LINCOLN CITY/LANCASTER COUNTY PLANNING STAFF REPORT

PROJECT #: Special Permit No. 1989A, Tamarin Ridge

PROPOSAL: Amend the lighting plan for Sid Dillon property located at 2627 Kendra Lane.

LIGHTING PLAN

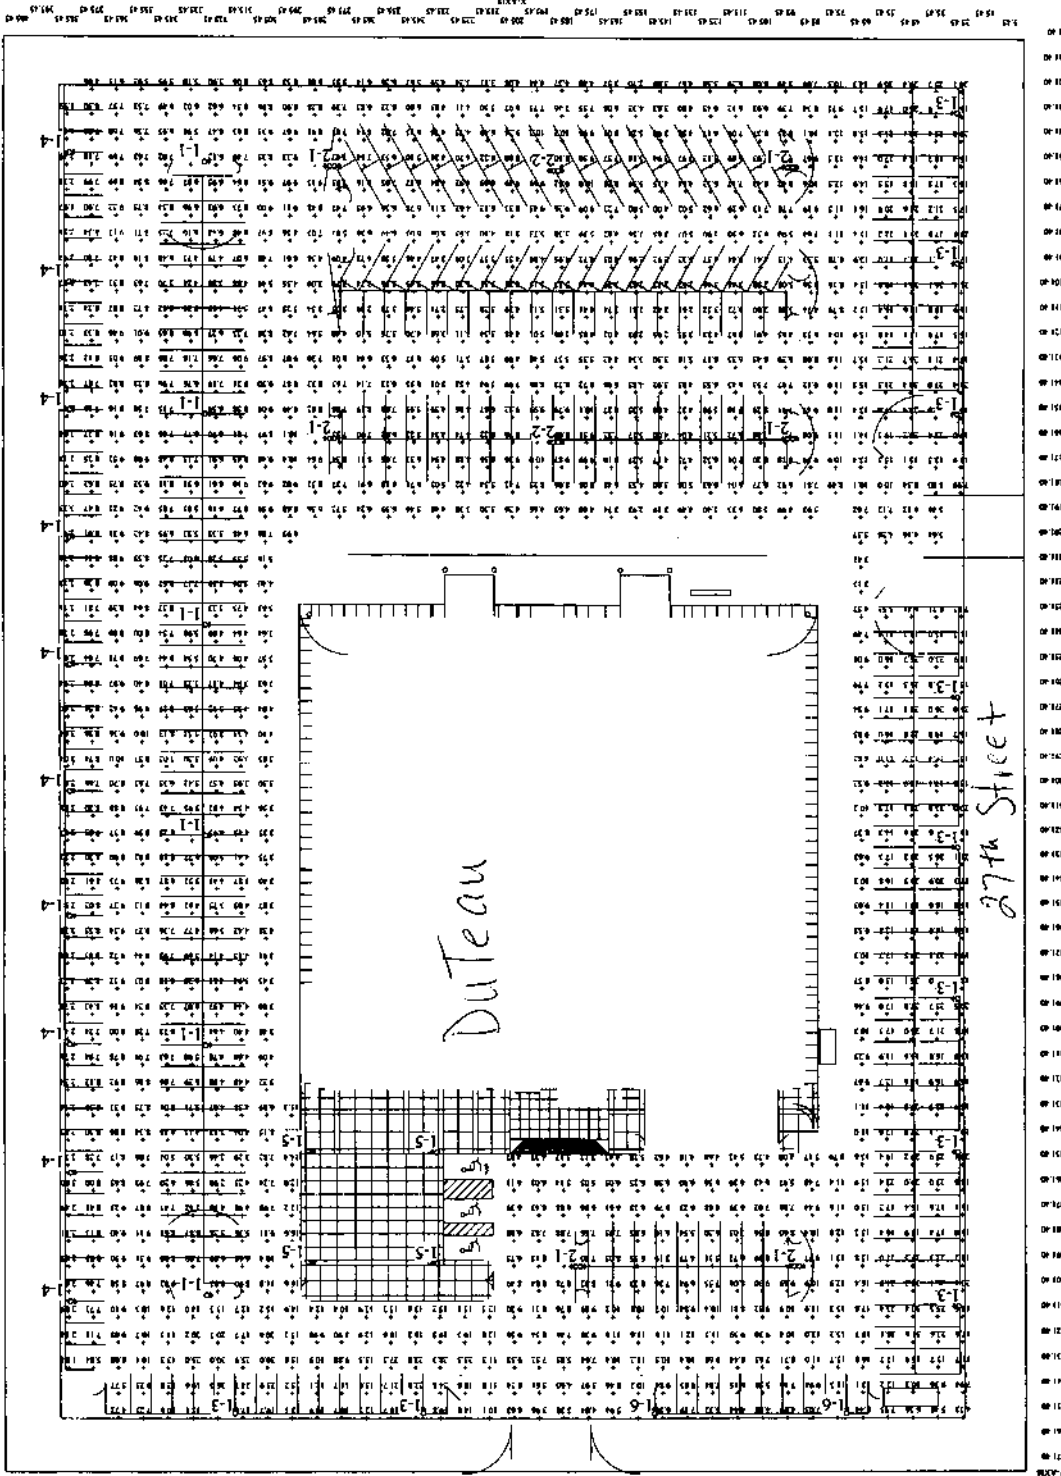
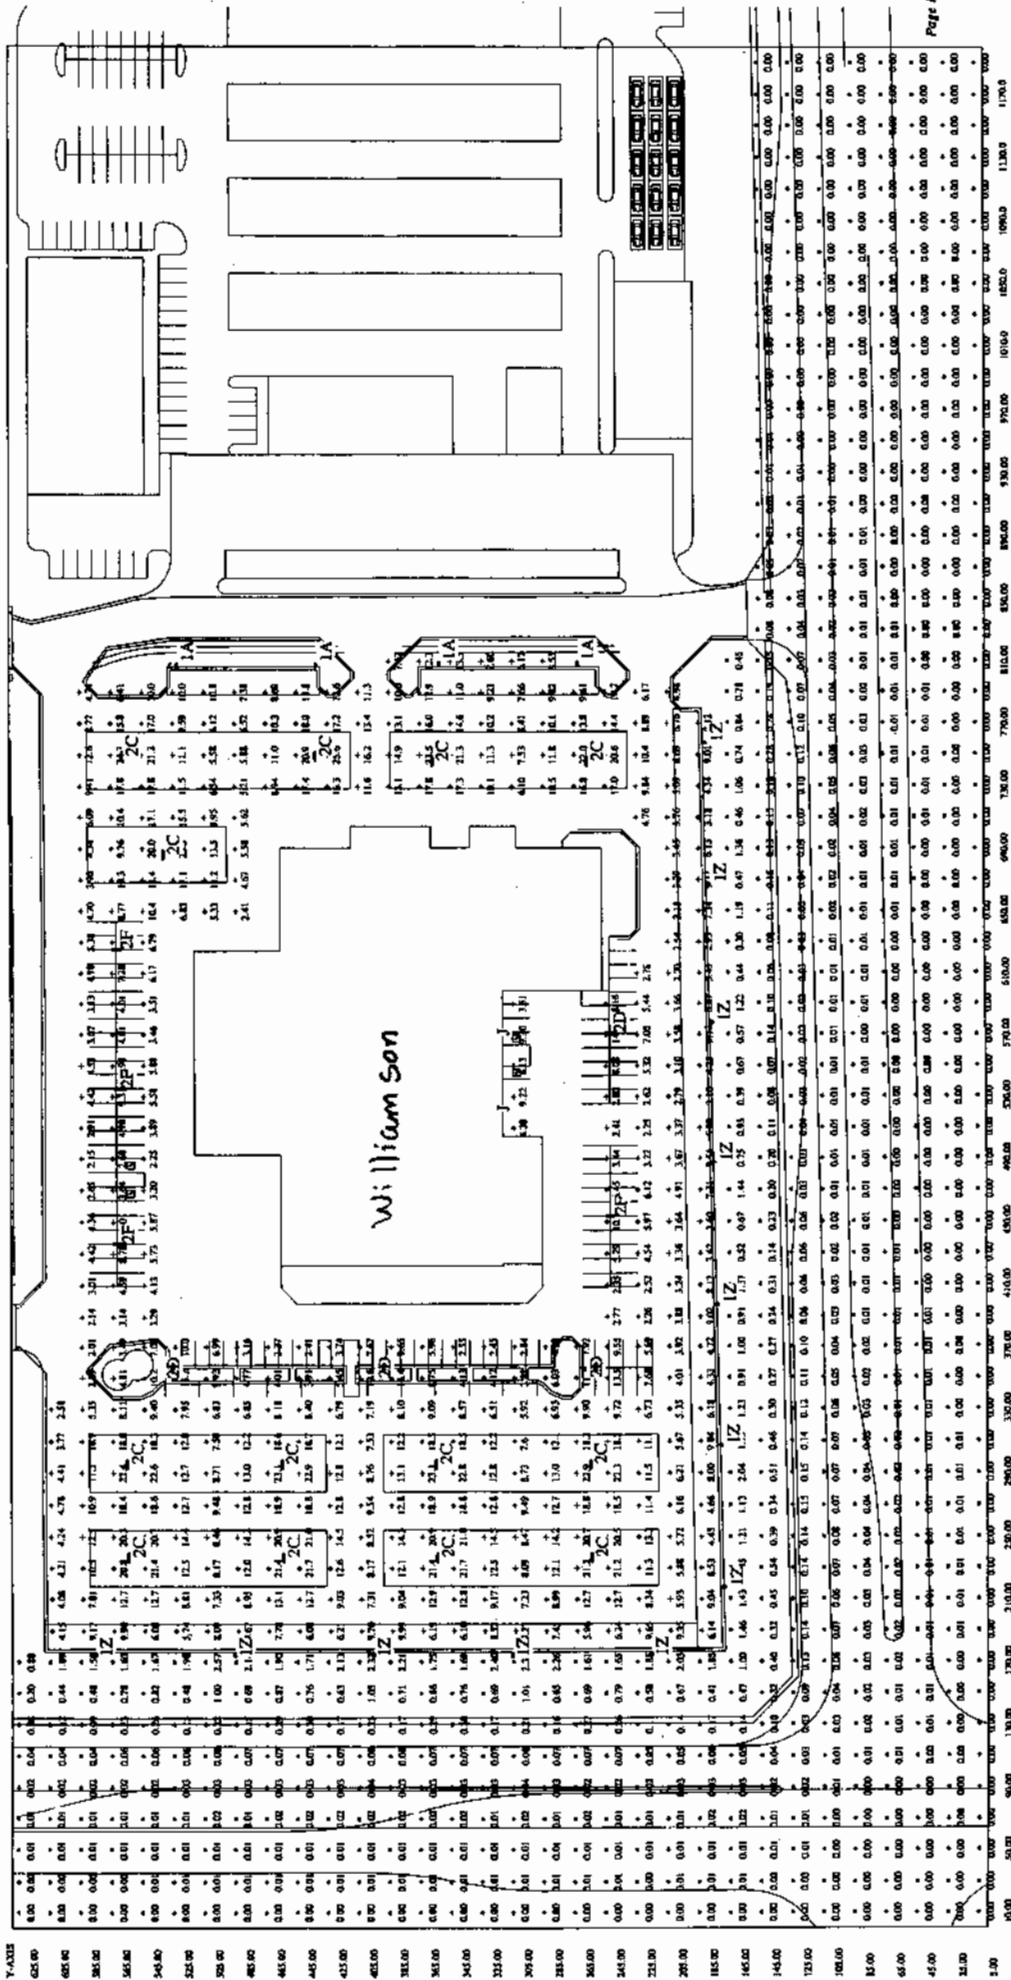
9. A lighting study on the DuTeau property was prepared by Olsson Associates for the administrative amendment for Williamson. The lighting study showed that the average footcandle for the entire DuTeau site was 9.20 and the proposed average footcandles for Williamson was 9.56. (see attached) DuTeau also uses full-cutoff fixtures. Although the lighting for DeTeau is more restrictive than as strictly stated in their conditions, DuTeau had verbally committed to minimize its impact.
